**ADDENDUM # 4****Renovation of Commons A**

WBA 21-034.01

**TO: All Bidders****DATE: 30 January 2023**

**Renovation of Commons Building A**  
**BID SET**  
Tuskegee University  
Benjamin F. Payton Drive, Tuskegee, AL 36088  
21-034.01

### TOILET ACCESSORIES

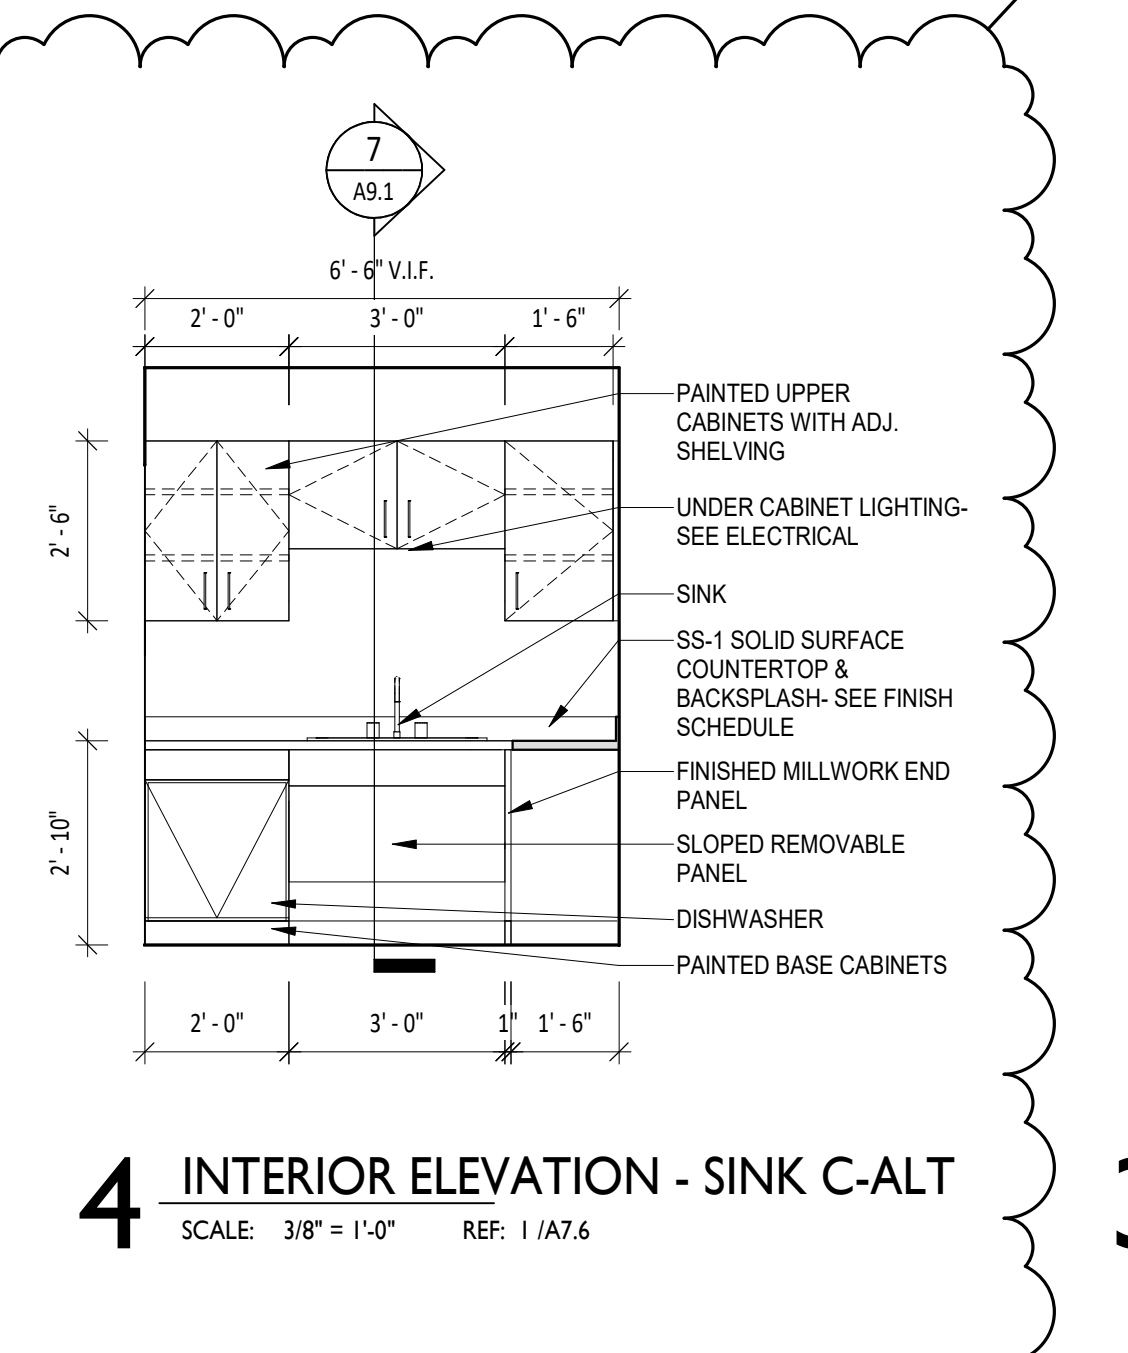
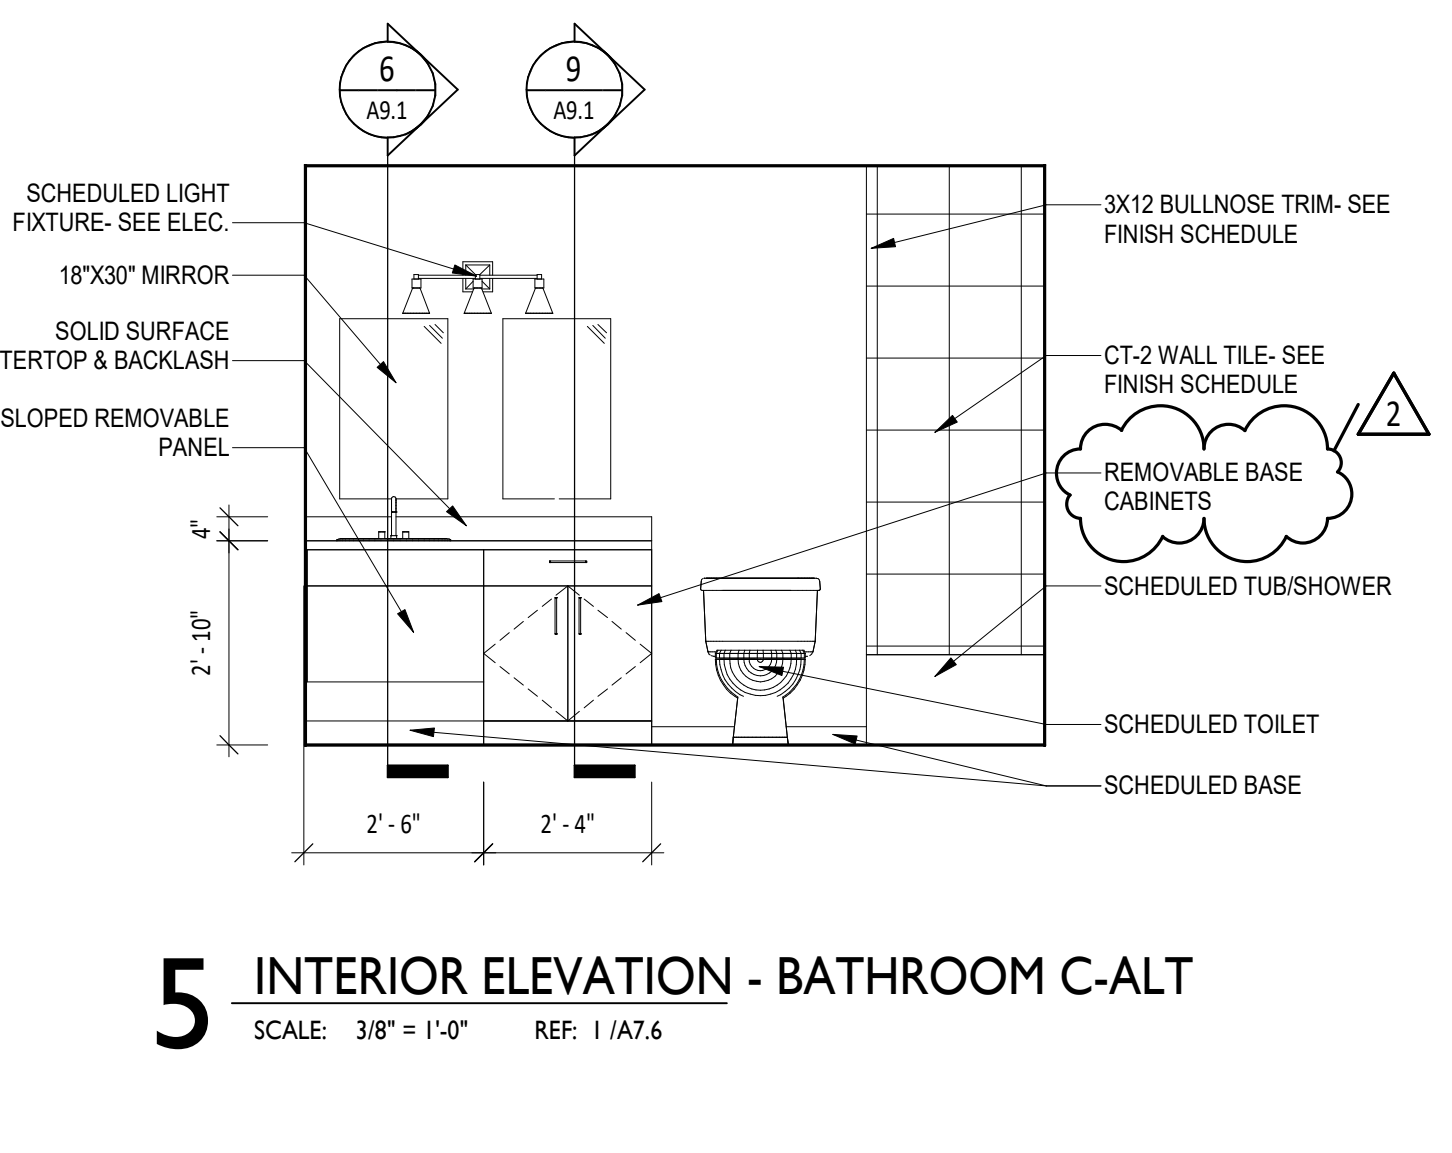
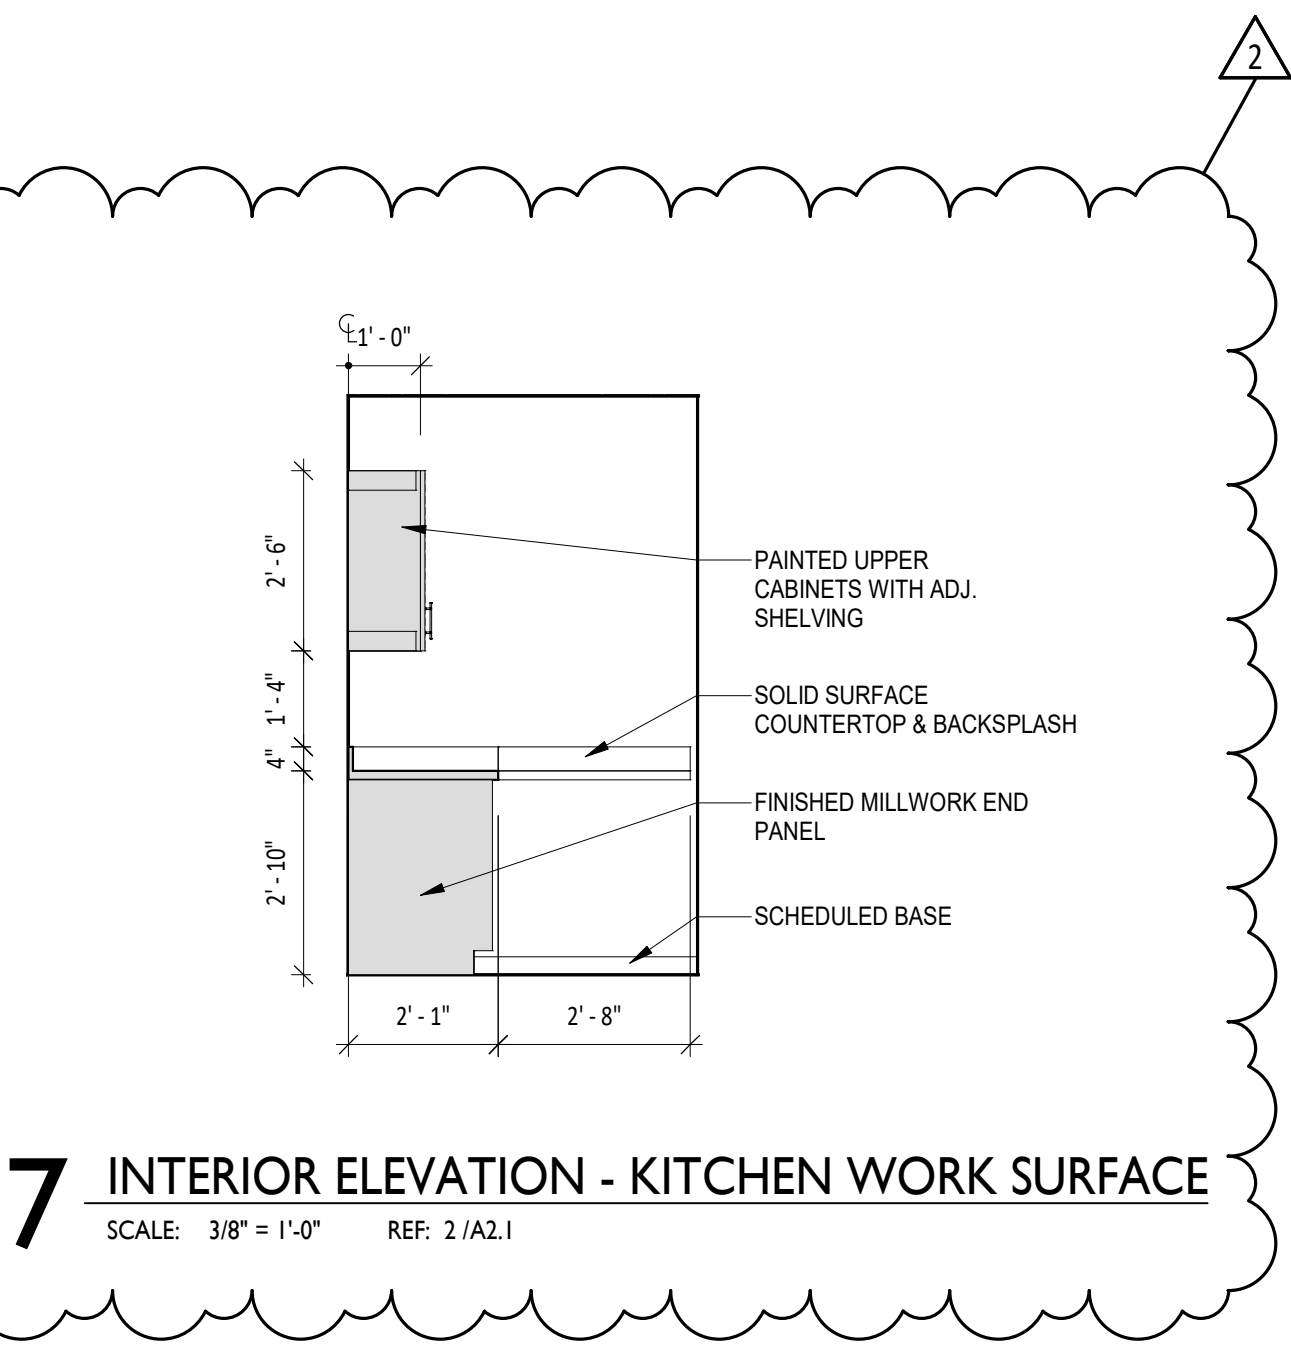
9. Sheet A7.6 – Updated ADA Compliances to incorporate DCM review comments.
